Public Service Company of Colorado

May 28, 1982
Fort St. Vrain
Unit No. 1
P-82169

Subject: Electrical Power Systems

References: 1) G-80149
2) G-80150

FIGURE 1 - ELECTRICAL SINGLE LINE
DIAGRAM P.T. ST. VRAIN INTERCONNECTION
TO PRIMARY POWER SYSTEM.

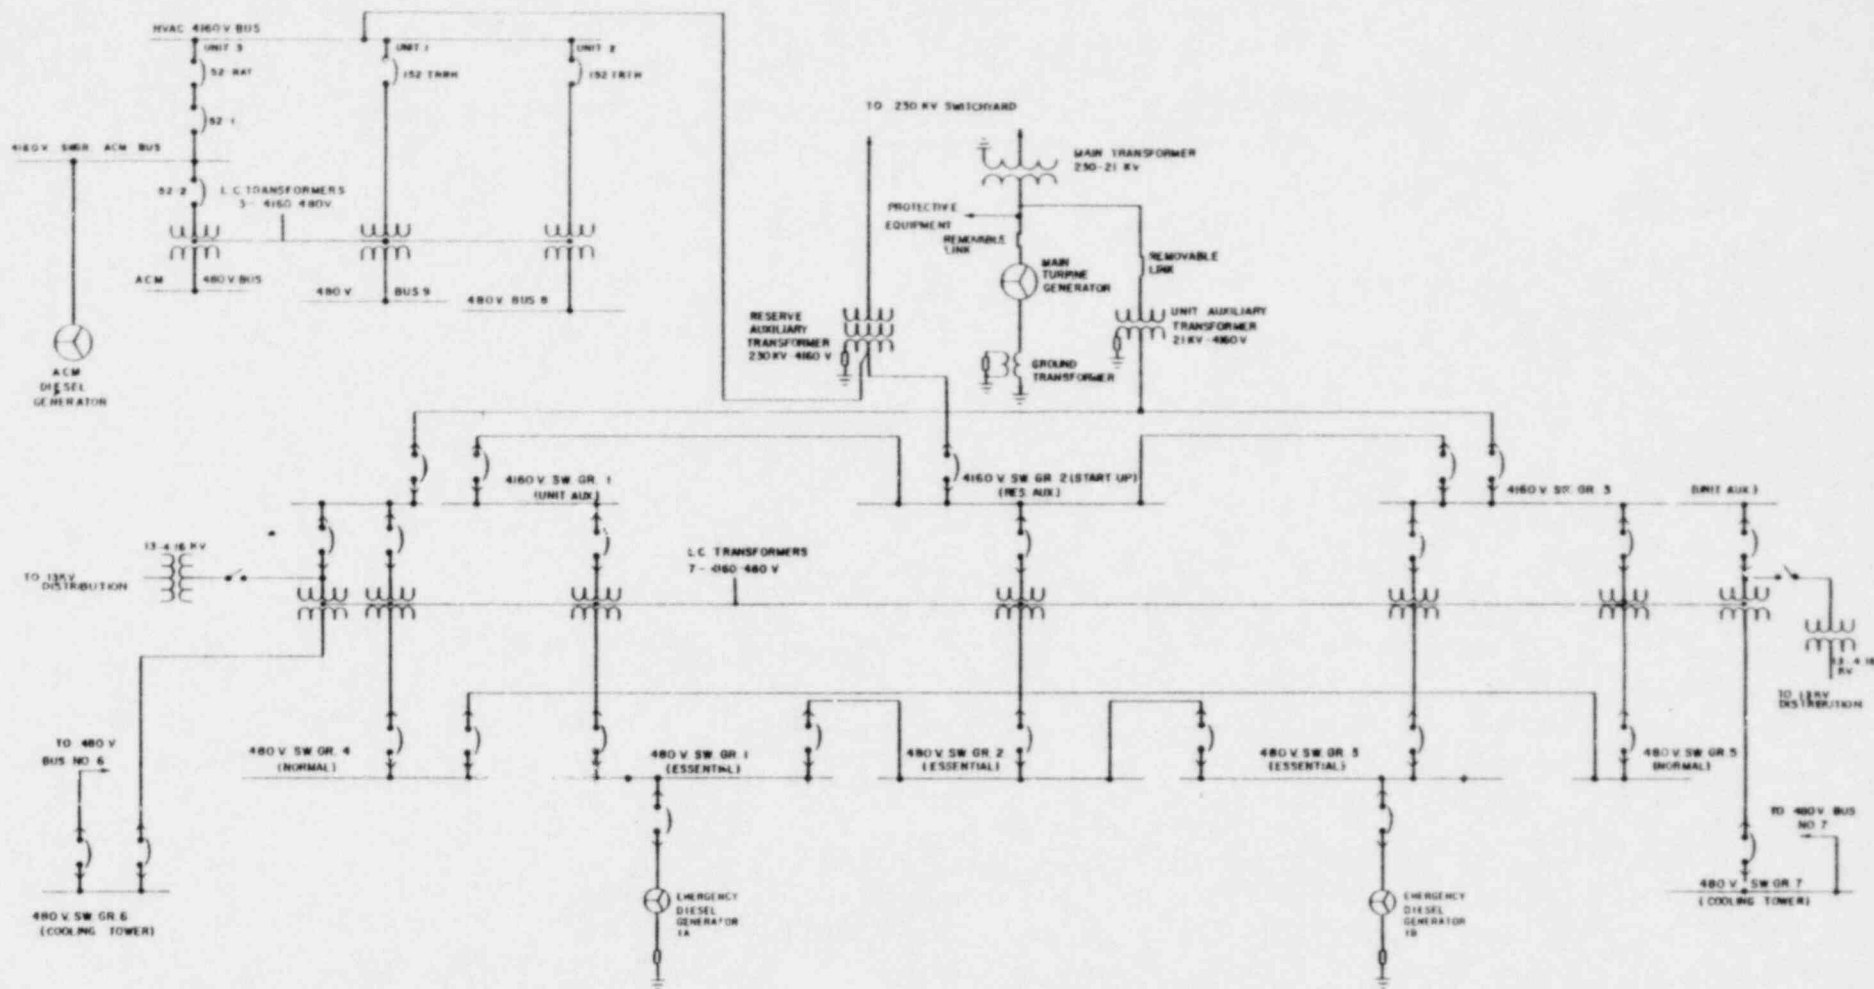
- (1) Based on the experience at ANO, the NRC is requiring all licensees to review the electric power systems at each of their nuclear power plants to determine analytically if, assuming all onsite sources of AC power are not available, the offsite power system is of sufficient capacity and capability to automatically start, as well as operate, all required safety loads within their required voltage ratings in the event of (a) an anticipated transient (such as a unit trip) or (b) an accident (such as a LOCA) regardless of other actions the electric power system is designed to automatically initiate and without the need for manual load shedding of any electric loads.

Five 230Kv transmission lines from widely separated power system grid locations are connected to the Fort St. Vrain switchyard (See Figure 1 of ATTACHMENT 3 for further details). Any one of these lines alone can easily handle the safe shutdown cooling load (less than 1 megawatt) at Fort St. Vrain. These lines are individually protected through the application of modern protective relaying practices, thus the simultaneous loss of all offsite power is extremely unlikely.

ATTACHMENT 3
FIG 3

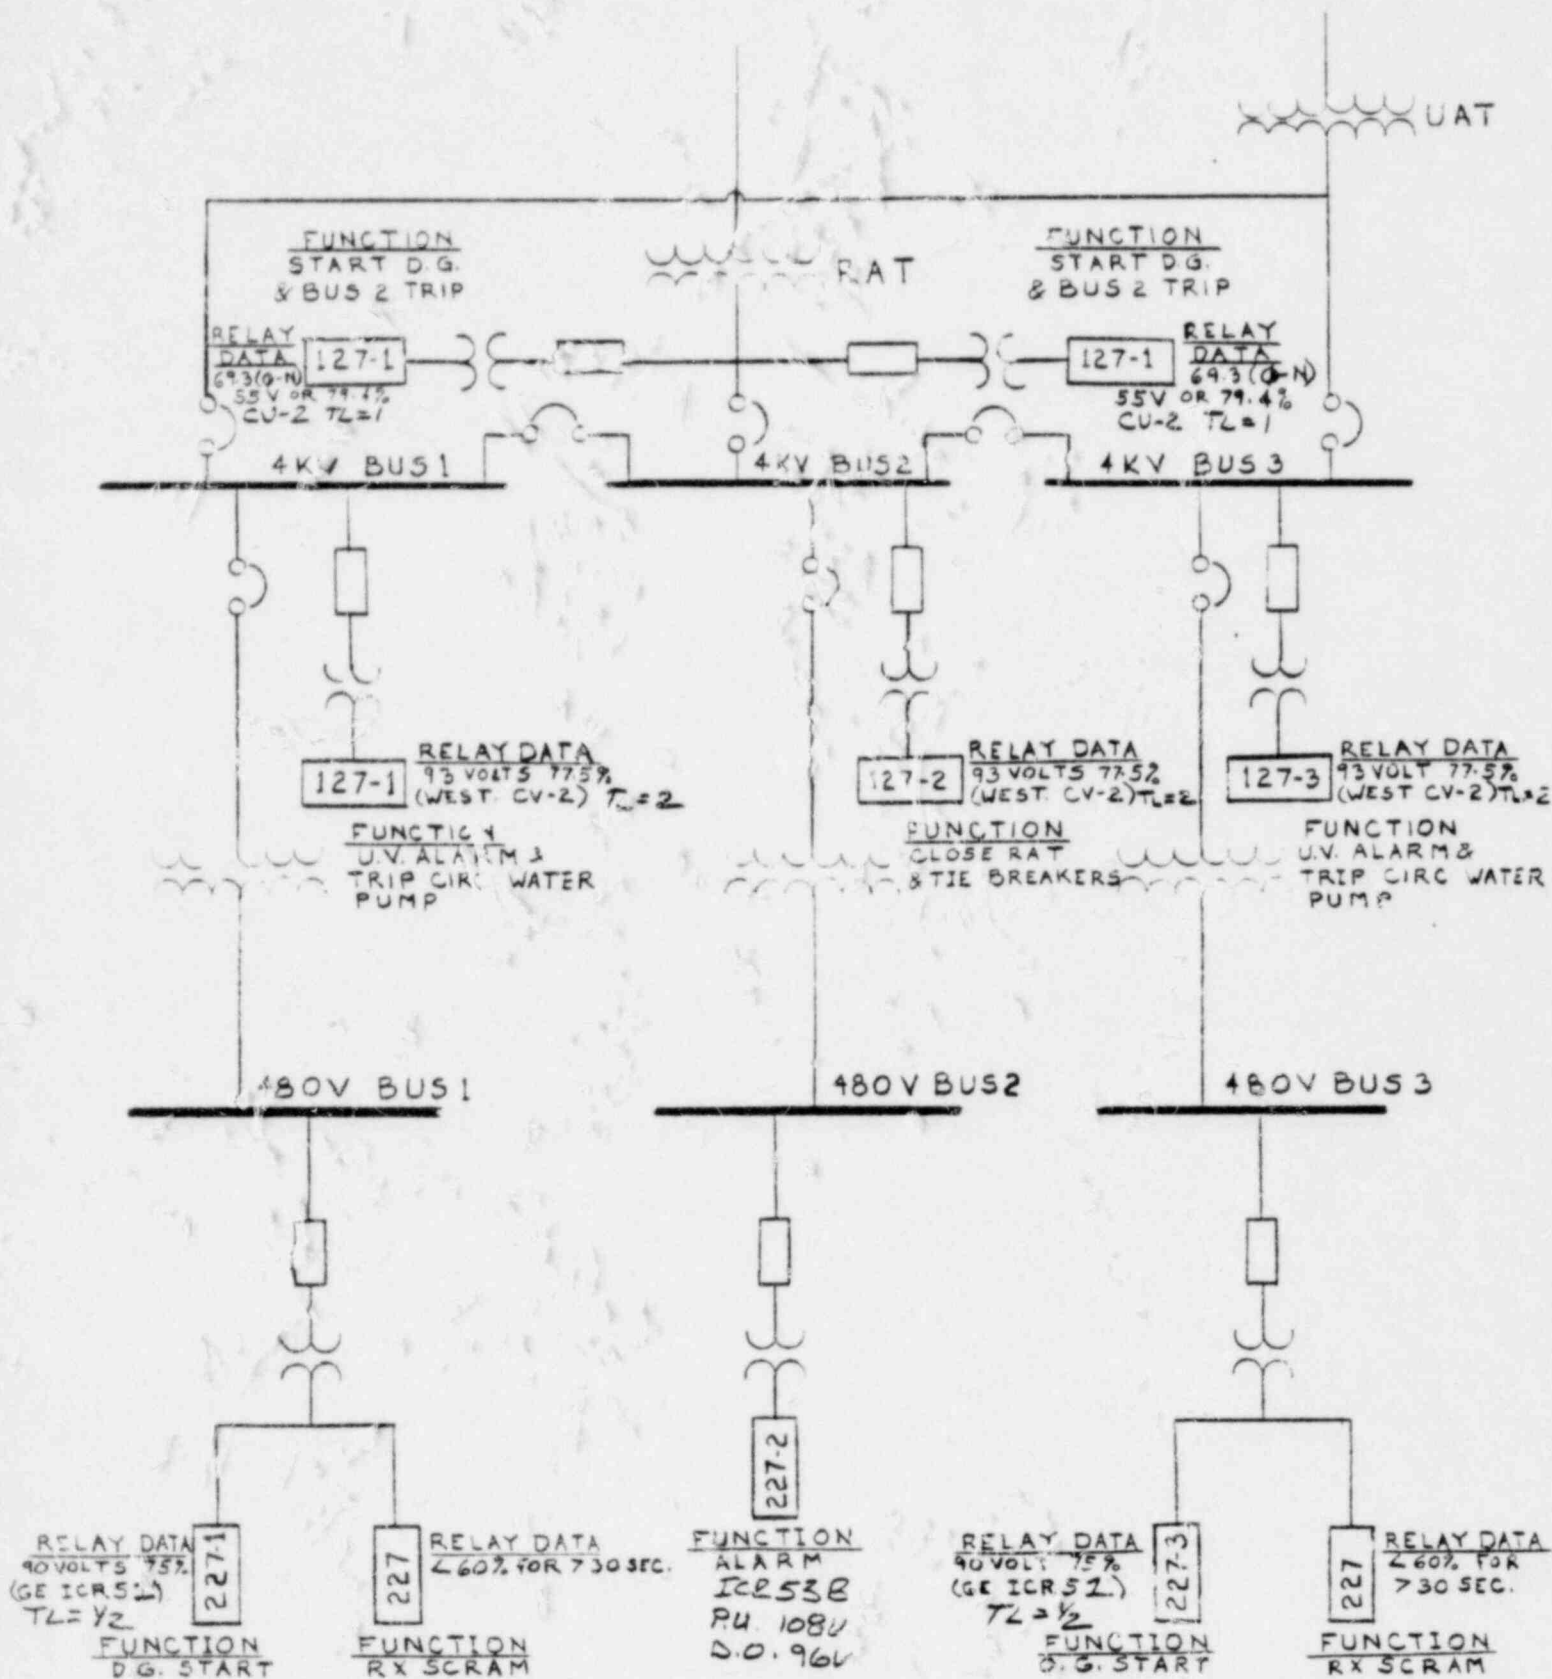
NRC Requests:

We request that you compare the current design of the emergency power systems at your facility(ies) with the Staff Positions stated in the enclosure and:

- (1) propose plant modifications as necessary to meet the Staff Positions, or
- (2) provide a detailed analysis which shows your facility design has equivalent capabilities and protective features.

As we indicated in our letter P-81317 (dated 12/16/81 Brey to Kuzmycz), PSC has been pursuing the upgrading of the 3 essential 480 volt buses. The most prudent method of implementing the two levels of undervoltage protection is to do so when the switchgear is being changed out (two units are scheduled to be replaced during the 3rd refueling). The remaining existing units' relaying would be modified to provide the same voltage protection as the new units at that time. It is felt that this is the most viable approach because of the difficulty associated with the timely purchasing of Class 1E voltage transformers and undervoltage relays to modify the existing switchgear.
